TECHNICAL SERVICE BULLETIN

ISSUE DATE:	10-2-2020
SERVICE BULLETIN SUBJECT:	VIP Sensor Clamp Retrofit
VINs or MODELS AFFECTED:	Service Specified Buses
COMPLETE BY:	Next Service Opportunity
SERVICE BULLETIN #:	SC-20-140
Labor Operation Code:	WD41Z

VIP SENSOR CLAMP RETROFIT

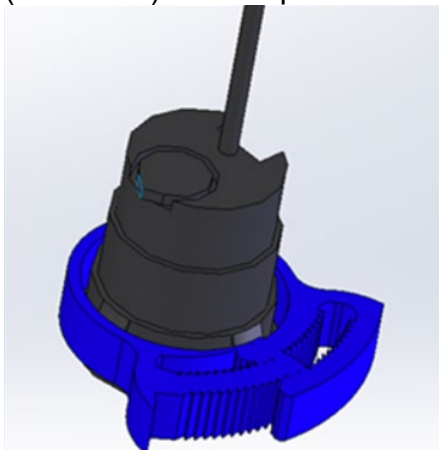
4. Using the following illustration as a guide, secure the three VIP Door sensors with Clamps (121-4723). Use Slip Joint Pliers to tightly lock the Clamps.
